SUPPLEMENTARY SUBMISSION — FURTHER COMMENTS OF A SUBMITTER

on the Applicant's Response to Council's Further Advice (lodged 15 October 2026)

Council Reference: A006918986

Site: 221 and 235 Murarrie Road, Tingalpa QLD 4173

Ellivo Architects, drawing DA-401 Rev 10 “Site Boundary Sections”, 13 October 2026 — Section 2

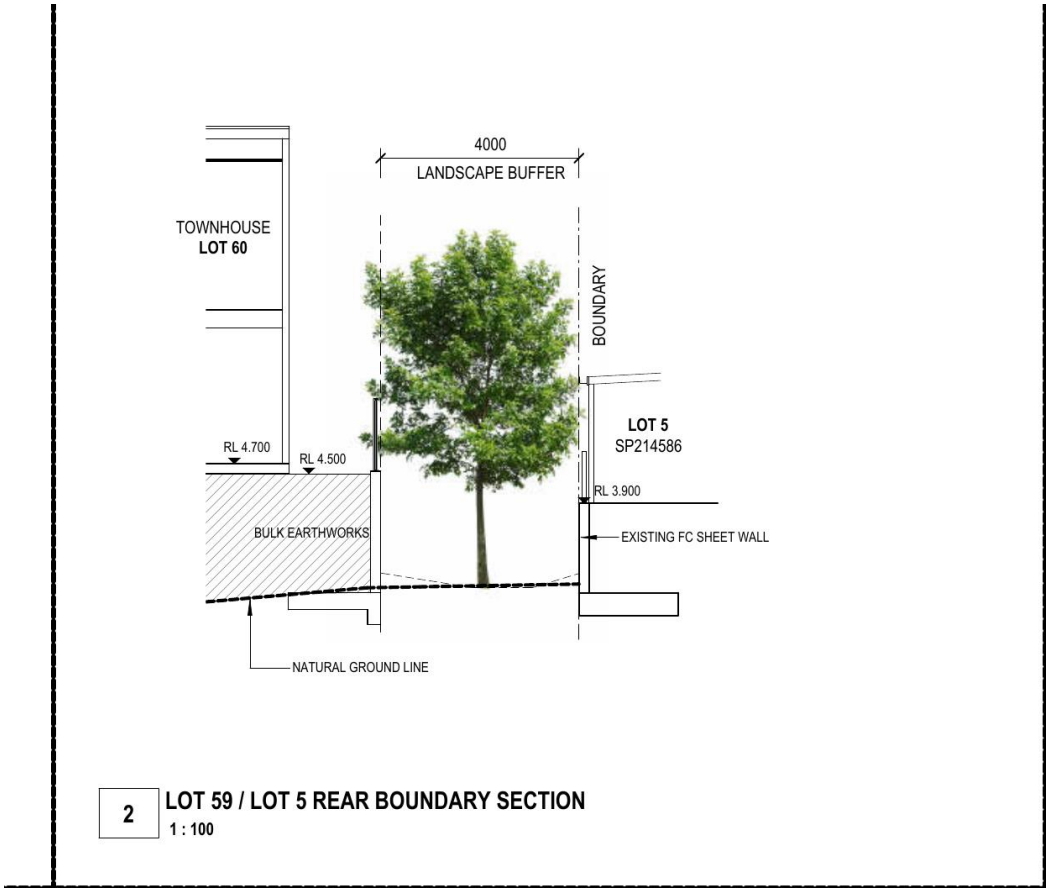
- **The landscape buffer at our boundary remains 4.0 metres.** The "4 m to 5.47 m" buffer described in the cover letter is not provided at Lot 5. Drawing DA-401 Section 2 ("Lot 59 / Lot 5 rear boundary section") shows 4,000 mm, a two-storey townhouse wall at the buffer edge, and a building pad 0.6–0.8 m above our ground level.

- **Drawing DA-401 Rev 10, Section 2 — "Lot 59 / Lot 5 rear boundary section"** (reproduced as Attachment A to this letter) dimensions the landscape buffer at **4,000 mm**.
- **Drawing DA-100 Rev 20** (extract at Attachment B) dimensions the buffer at **4000** adjacent to Units 60–62. The only wider buffer dimension on that plan, 5477, is at Units 63–68. The 9083 and 6790 figures on the same plan are setbacks from the boundary to the walls of Units 63–68 and Unit 75 respectively, not buffer widths. By comparison the wall of Unit 60 is dimensioned **5,821 mm** from our boundary. Only Unit 76, at 5,114 mm opposite Lot 15, is closer; every other townhouse along the southern boundary is set back further (Units 63–68 at 9,083 mm, Unit 75 at 6,790 mm). The two closest walls on the southern boundary are therefore both behind the minimum 4 m buffer, not the widened one.

We also note that Section 2 is titled "Lot 59 / Lot 5" but depicts "Townhouse Lot 60", and that the widened buffer at Units 63–68 is dimensioned 5,477 mm on DA-100 (and 5.47 m in the cover letter) but 5,447 mm on DA-401 Section 4. The drawings should be corrected, and any approved plans made internally consistent, so that Council and the adjoining owners can be certain which building is proposed opposite each boundary and what buffer width the developer is bound to.

Section 2 of DA-401 shows the townhouse pad at RL 4.50–4.70 m AHD against ....
fill of 0.6 to 0.8 metres — with a retaining wall at the edge of the buffer, a 1.2 m pool-style fence above it (Landscape Concept Plan Sections B and C), and the side wall of a two-storey Type A townhouse at the inside edge of the 4 m buffer. Level 1 windows of that dwelling will ....
. This reinforces, rather than answers, the overlooking and visual bulk grounds in our original submission (Multiple dwelling code PO9/AO9.4 and the code's privacy and overlooking outcomes). No overshadowing analysis has been provided at any stage of the application.

Source: Attachment B to the applicant’s Further Advice Response, lodged 15 October 2026. Note the 4,000 mm landscape buffer, the townhouse pad at RL 4.50–4.70 against RL 3.90 on Lot 5, and the two-storey wall at the inside edge of the buffer.

(e) The landscape buffer along the entire southern boundary, including the frontage to Lot 5 on SP214586, is to be a minimum of 5.5 metres wide, of which not less than 4 metres is deep planting unobstructed by retaining walls, swale batters, fences or footings.

(g) No retaining wall exceeding 1.0 metre in height is to be constructed within 4 metres of the southern boundary; the finished ground level within 4 metres of the boundary is to match existing natural ground level.
